Subject: Response to U.S. EPR Design Certification Application RAI No.406, FSAR Ch. 9, supplement 5

QUESTIONS for Balance of Plant Branch 1 (AP1000/EPR Projects) (SBPA)

Question 09.02.02-109:**Follow-up to RAI 334, Question 9.2.2-61 and RAI 174, Question 9.2.2-12**

Figure 2.7.1-1—Component Cooling Water System Functional Arrangement
Sheet 2 of 11

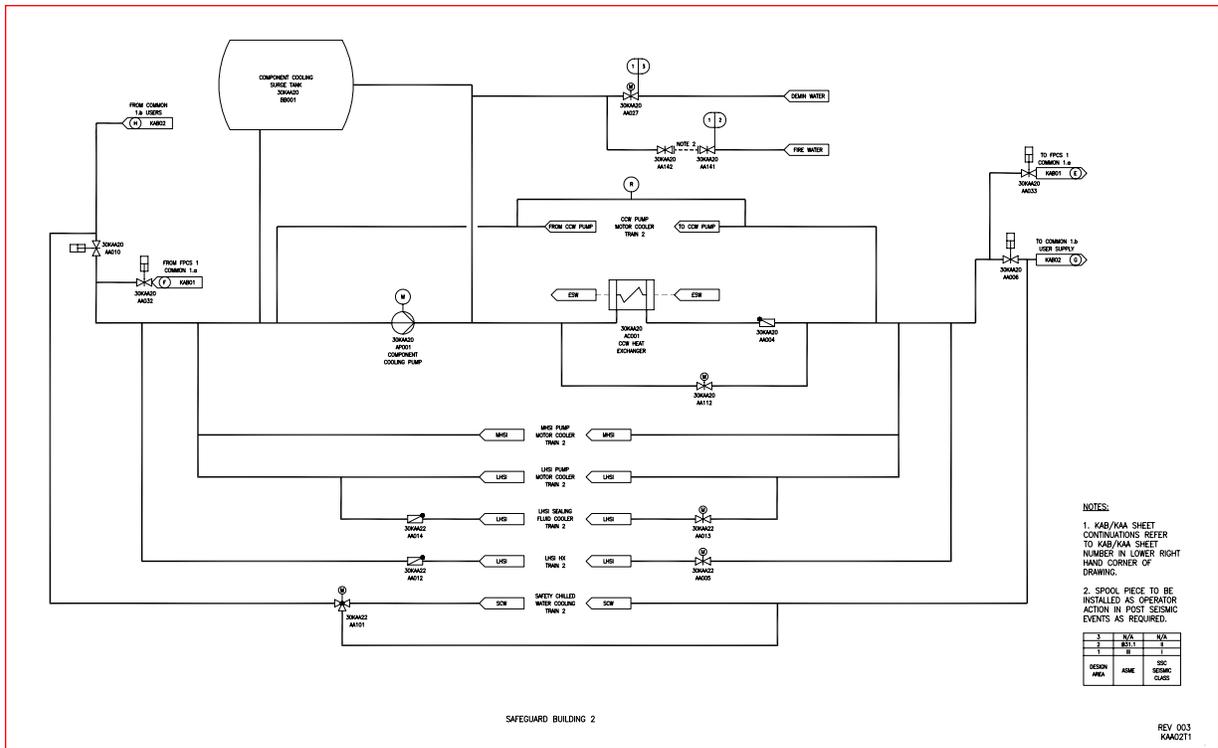
Part 6: In Part 6 the applicant was asked to simplify the 24 page CCWS functional arrangement drawing in Tier 1 (Figure 2.7.1-1). Accordingly the applicant provided a simplified version (11 pages) of Figure 2.7.1-1. The staff found the revised drawings were acceptable but noted that pipe transitions between ASME Class 2 and Class 3 need to be added as appropriate for the CCWS containment penetrations. This is based on SRP 14.3, Appendix C, page 14.3-35, "Figure Check List". The applicant needs to correct the Tier 1 FSAR markup accordingly.

Pipe transitions between ASME Class 2 and Class 3 for the CCWS have been confirmed. U.S. EPR FSAR Tier 1, Figure 2.7.1 will be revised to include this information. U.S. EPR FSAR Tier 1, Figure 2.7.1 will also be revised to include the radiation monitors for the main CCWS trains and the radiation monitors on the inlet and outlet of the CVCS HP coolers that were originally included in the Response to RAI 174, Supplement 2, Question 09.02.02-30.

09.02.02-109 (Part 6)

Figure 9.2.2-2—Component Cooling Water System Common Loop 1
Sheet 7 of 7

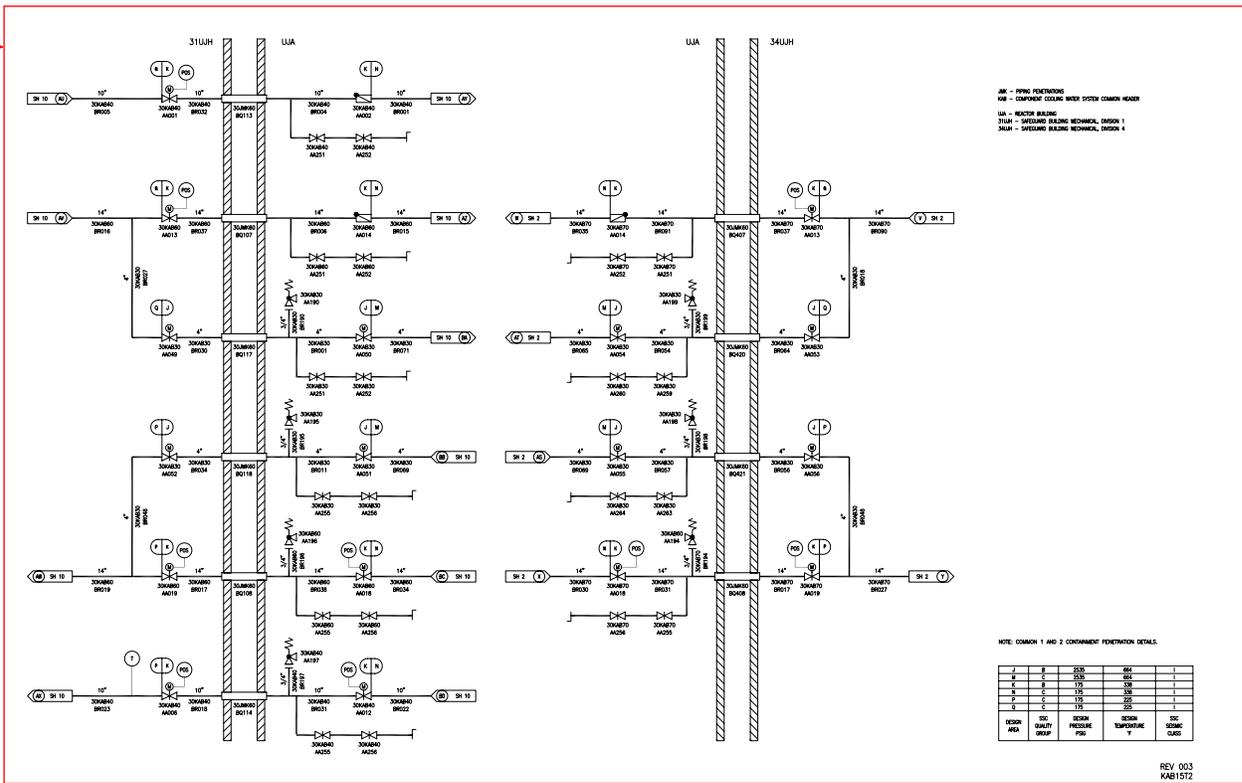
- a. In regard to the discussion in the response about mid position failure of a thermal barrier containment isolation valve (CIV) upon attempting transfer of thermal barrier cooling to the other common header:

A reduction or loss of CCWS flow to any of the RCP thermal barriers is recognized in the control room by individual flow indication devices in the return piping from each thermal barrier (refer to U.S. EPR FSAR Tier 2, Figure 9.2.2-2, sheets 3 and 4 and Figure 9.2.2-3, sheets 3 and 4). A reduction or loss of CVCS seal injection flow to the RCPs is recognized in the control room by a totaling flow indication device outside containment, and individual flow indication devices for each RCP seal (refer to U.S. EPR FSAR Tier 2, Figure 9.3.4-1). Refer to the Response to RAI 53, Question 19-206 for a discussion of simultaneous loss of thermal barrier cooling and seal injection flow. If CCWS flow to the thermal barriers is not recovered after two minutes, the seals will heat up, resulting in increased seal leakage and the standstill seal closure would be in effect. Refer to U.S. EPR FSAR Tier 2, Section 15.6 for the U.S. EPR loss of coolant accident (LOCA) analysis. In the absence of RCP seal injection via CVCS and RCP thermal barrier cooling via CCWS, the RCP shaft seal average leakage is assumed to be ≤ 25 gpm until the standstill seal system closes (Refer to the Response to RAI 174, Question 09.02.02-20).

09.02.02-114
